UNITED STATES ENVIRONMENTAL PROTECTION AGENCY  
WASHINGTON, D.C. 20460

OFFICE OF  
AIR AND RADIATION

In a December 10, 2002, letter from Dr. Triay, the Department of Energy (DOE) requested our approval to dispose of standard waste and compressed waste from the Idaho National Environmental and Engineering Laboratory's (INEEL) Advanced Mixed Waste Treatment Facility (AMWTF) at the Waste Isolation Pilot Plant (WIPP). (Docket A-98-49, Item II-B2-15; all subsequent citations to same docket) We approved the disposal of standard transuranic waste from the AMWTF in a June 2003 letter, and recently approved related waste characterization processes at the facility. (II-B3-56, II-A4-42) Subject to EPA quality assurance and waste characterization inspections, with this letter we now approve disposal of compressed (super-compacted) waste at WIPP with the requirement to place additional magnesium oxide (MgO) with the compressed waste to maintain the current safety factor.

**Figure 1.**  
**Compressed waste pucks as generated**  
**in the AMWTF**  
(Source: DOE)

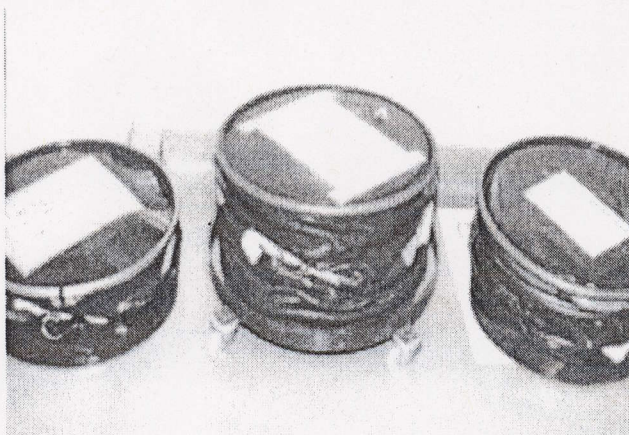
The AMWTF at INEEL is designed to retrieve, characterize, repackage, and compress 55-gallon drums of contact-handled, mixed transuranic debris waste. The compressed AMWTF waste will consist of 55-gallon steel drums of debris waste compressed vertically, resulting in flattened cylinders called "pucks" (see picture below). These pucks would be placed in 100-gallon steel drums for shipping and disposal at WIPP.

Each 100-gallon drum is expected to contain from 3 to 5 pucks, with an average of 4 pucks per drum. If these pucks do not degrade, the pucks will be stronger and more rigid than the standard waste, potentially propping up the room ceiling.
